Access Compliance Report

Public Rights-of-Way

(Curb Ramps)

Intersection ID: 29231	Main Street: KORNIV_DR	Cross Street: COPPALA_DR	Location: NE
ADA ID: FF5AF4627609	Ramp Type: BlendTrans1	Initial Pass/Fail: Pass	Overall Compliance: No
		Severity Score: 15

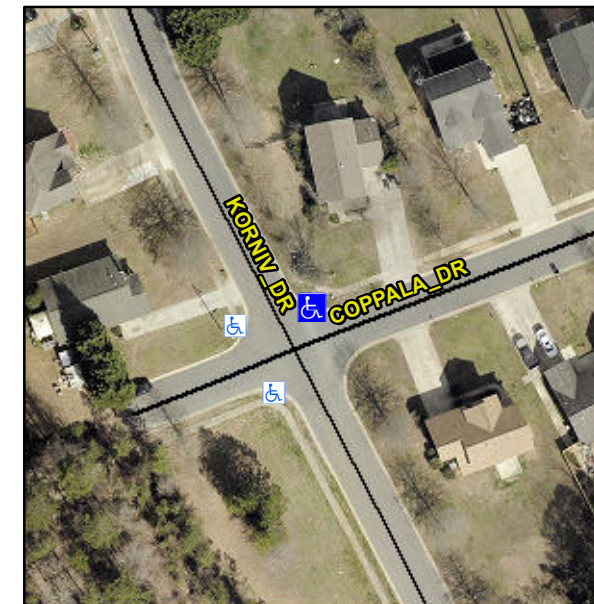
Not Found, R304.2.1, R304.2.2-Perp, R304.3.2-Para, R305.1.4, R305.2, R302.7.2, R304.5.4

N/A	Ramp inside XWalk1?	N/A	N/A	Ramp inside XWalk2?	N/A
	Road Slope (%)	0.7		Clear Space?	Yes
	Road X Slope (%)	0.2	N/A	Clear Space to XWalk (in)	N/A
Yes	Any Obstructions?	No	Yes	Storm Grate/Utility Hazard?	No
	Obstruction Type			Storm Grate/Utility Type	
			N/A		N/A
			Yes	Surface Condition? (G/P)	Good
			No	Curb Slope (%)	11.7

Remove & Replace Curb Ramp With Two New Directional Ramps or Equivalent. Remove & Replace Gutter.
